Rockwell service letter No. SL-AG-75

Service Letter No. SL-AG-75
October 1, 1975

CARBURETOR AIR BOX CONTROL CABLE CLAMP REPLACEMENT

MODELS AFFECTED: MODEL S-2R, S/N 5000R thru 5082R.

Figure 1.

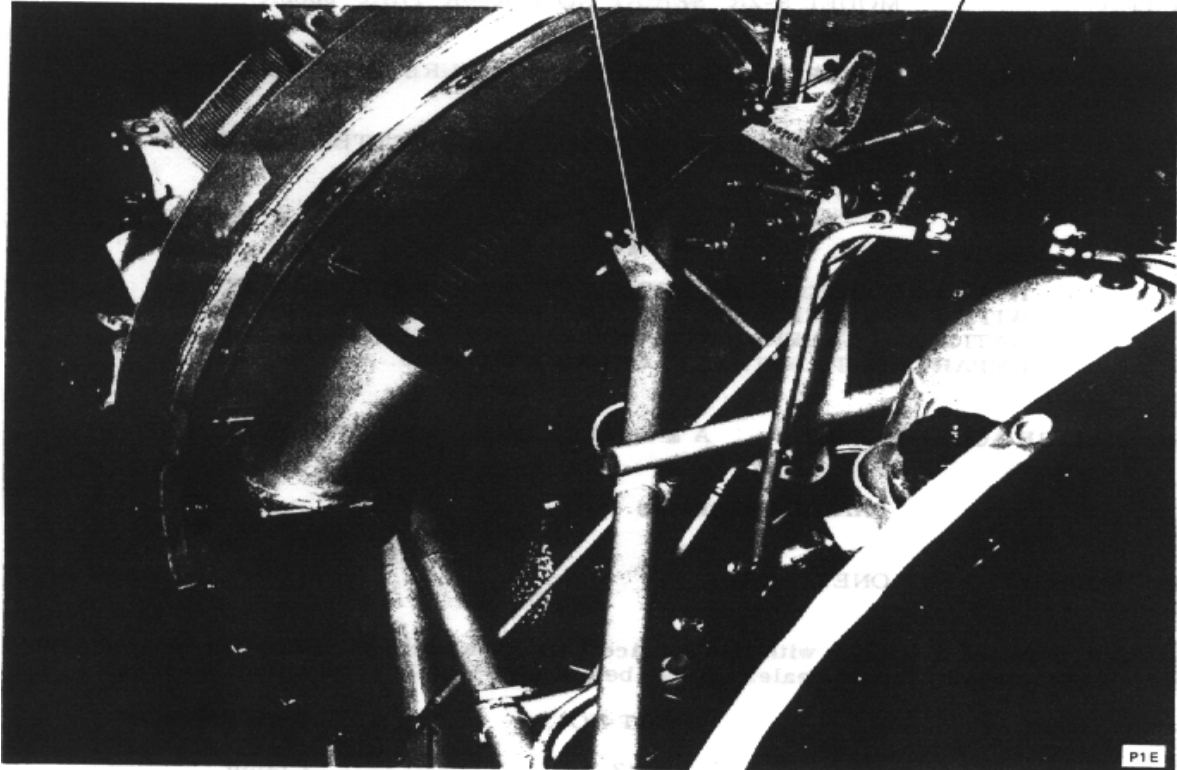
1. Remove upper engine cowling.
2. Remove and discard existing lower clamp and bracket from carburetor air box control cable (see Figure 1.).
3. Remove and discard existing upper clamp from carburetor air box control cable and install AN742-4F clamp using existing hardware (see Figure 1.).
4. Reinstall upper engine cowling.

REMOVE AND DISCARD
EXISTING CLAMP AND BRACKET

REMOVE EXISTING CLAMP
AND INSTALL AN742-4F CLAMP
USING EXISTING HARDWARE
